ASSESSMENT REPORT

Section 75W Modification Borg Panels – Gas Fired Cogeneration Units (DA 27/95 MOD 8)

Figure 3: Site layout and location of the proposed cogeneration units

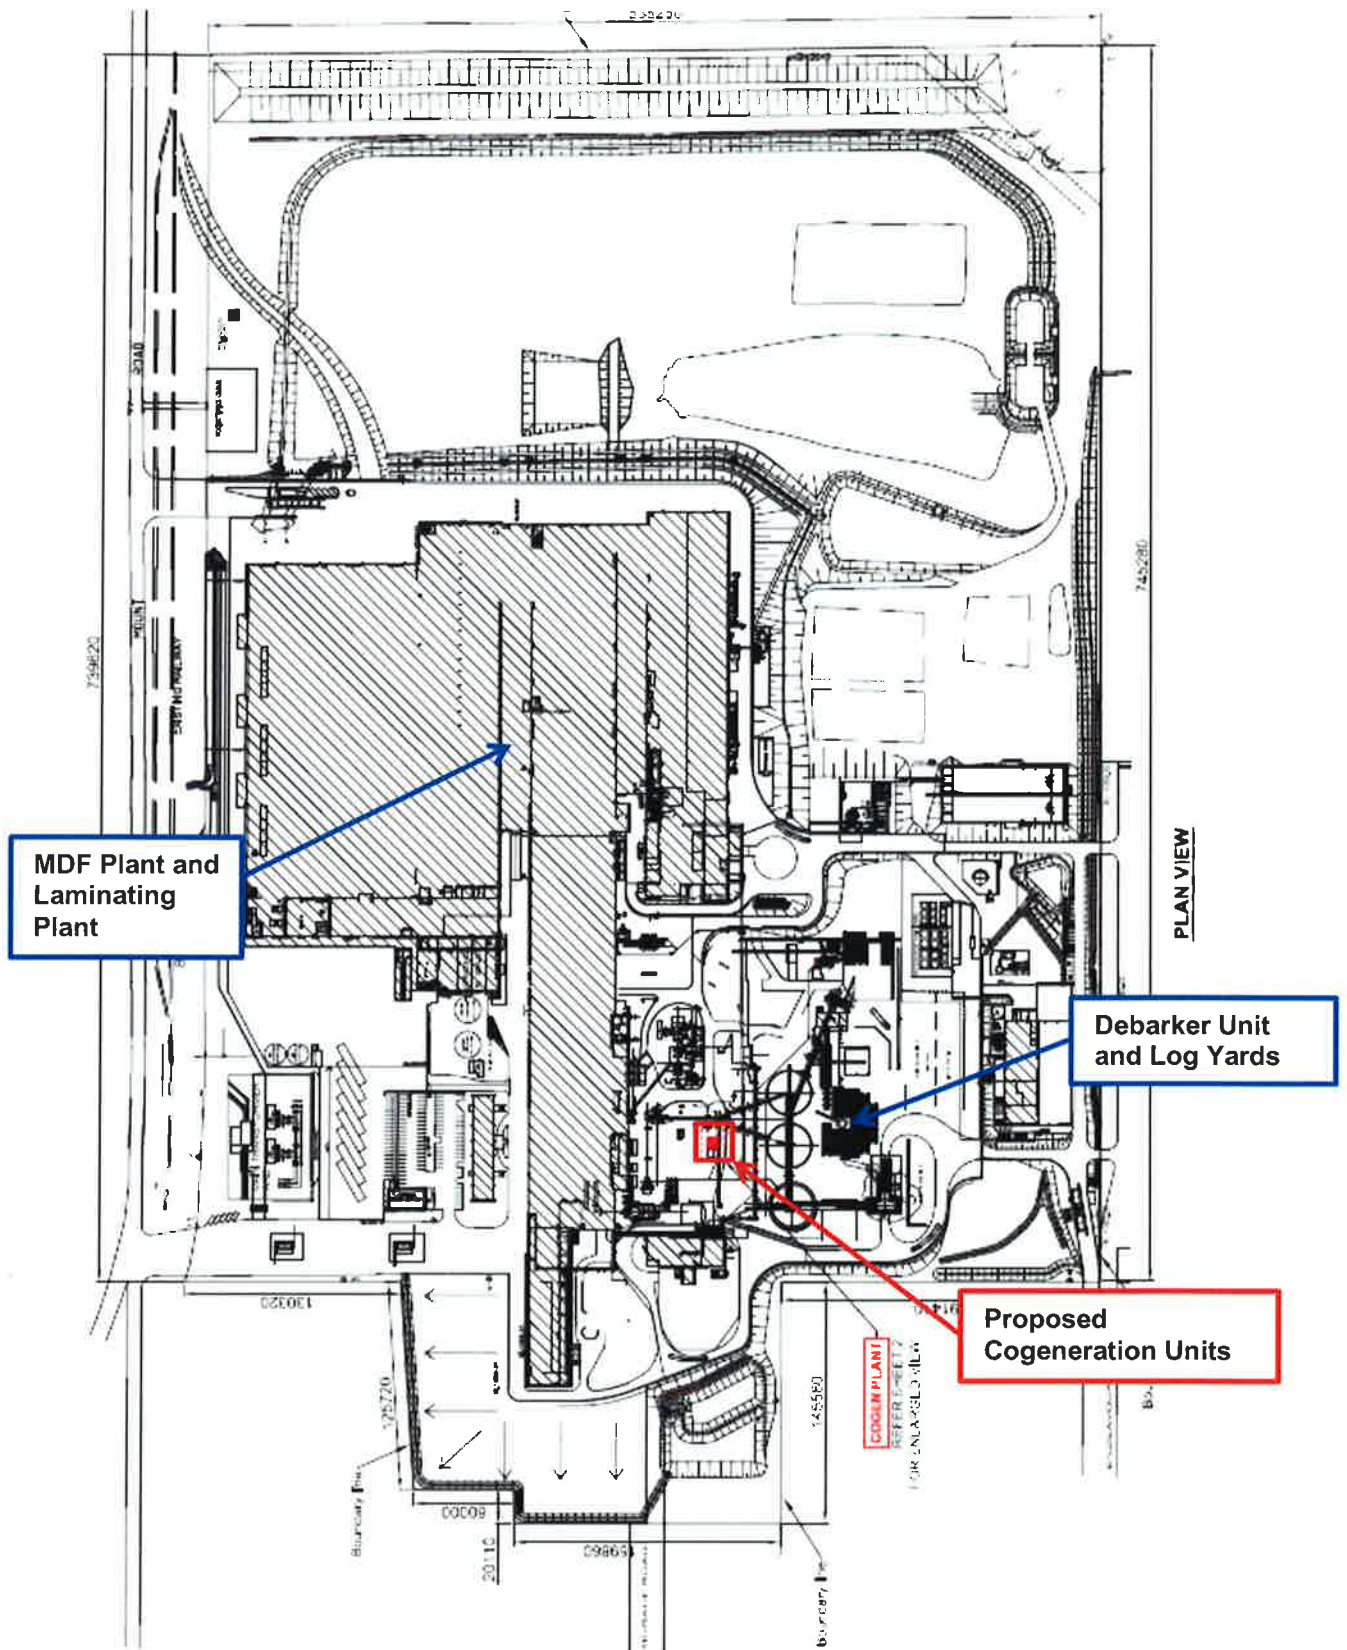
The cogeneration units would be located in the middle of the site next to the existing laminating plant and the log yards and are proposed to be enclosed within a steel enclosure which would be internally lined with insulation (See **Figure 3** and **4**). The steel enclosure would have three open areas: an air intake vent, air discharge vent and an exhaust pipe that run from the muffler on the cogeneration units to the process plant. The NIA stated that these open areas would be the primary noise sources related to the proposed cogeneration units.

In its submission, the EPA sought clarification on cumulative noise impacts arising from the existing operation and proposed noise attenuation strategies. The Proponent provided a revised NIA which confirmed that the cogeneration units would be acoustically treated to achieve the predicted noise levels outlined in the initial NIA.

Based on the information in the revised NIA, the Department and EPA consider that noise impacts from the proposal would be negligible provided that the cogeneration units are acoustically treated. The Department and the EPA are satisfied that the cogeneration units would not contribute to existing noise levels on the site as existing noise would generally mask noise emitted from the new cogeneration units. To ensure that the cogeneration units do not exceed noise limits at the nearest sensitive receivers, the EPA has recommended that post commissioning noise testing be undertaken by the Proponent.

- ensure that the cogeneration units are acoustically treated to achieve the predicted levels described in noise impact assessment; and
- undertake post commissioning noise monitoring of the cogeneration units to demonstrate compliance with EPA noise limits. Should compliance not be achieved with the existing noise limits for the facility, additional acoustic mitigation would be required.

Figure 5: Nearest sensitive receivers to the site

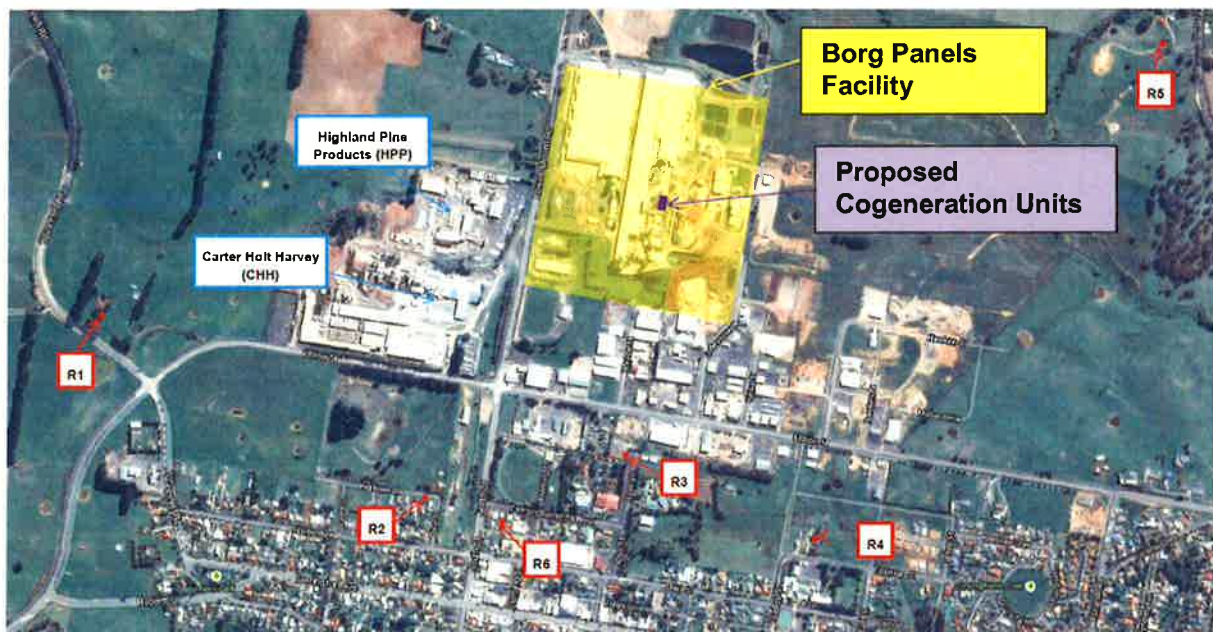
The NIA also considered cumulative noise levels taking into account noise from the cogeneration units and existing operations. The NIA concluded that the potential cumulative noise impacts are likely to be negligible at each of the sensitive receivers, except at R3 (Oberon High School, 680m south, see **Figure 5**) and R4 (a residential address – 10 Tasman Road), where there is a predicted minor increase of 1 dB(A) to 38dB(A) at R3 during daytime periods and 42 dB(A) and 44dB(A) at R4 during daytime and evening periods. This minor increase is generally not perceivable and the cumulative noise levels are still below the applicable noise criteria for daytime and evening periods. The NIA also stated that noise from the existing facility and other industrial activities in the surrounding area are likely to mask noise from the cogeneration units.
